New and Improved ICC Voice/Data Modular Connectors

La Mirada, CA— October 23, 2009

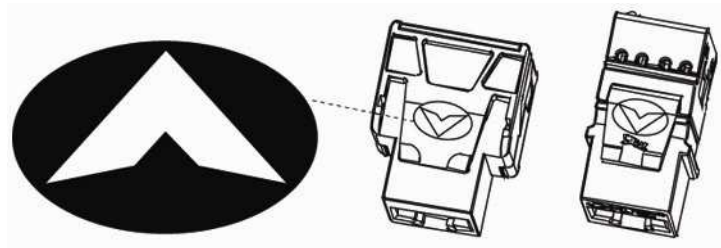
In an effort to improve performance and streamline termination of voice and data modular connectors, ICC has made some changes to the wiring scheme along with changes to the housing. CAT 5e, CAT 6 and CAT 6a modular connectors now all have the same pair-to-pair wiring scheme for improved performance. In addition, the IDC height has been increased for easy wire placement and improved cable retention. Since both voice and data modular connectors now have the same housing, a brand new 4-pair combo termination tool will be made available soon for terminating both EZ/HD voice and data connectors. No more carrying around different tools for each kind of connector. (Single blade punch-down tool* can still be used for termination.)

*Current 4-pair EZ/HD tools are not compatible with the new connectors. A free exchange program will be available soon. For termination tool options please speak with ICC product support at 888-ASK-4-ICC.
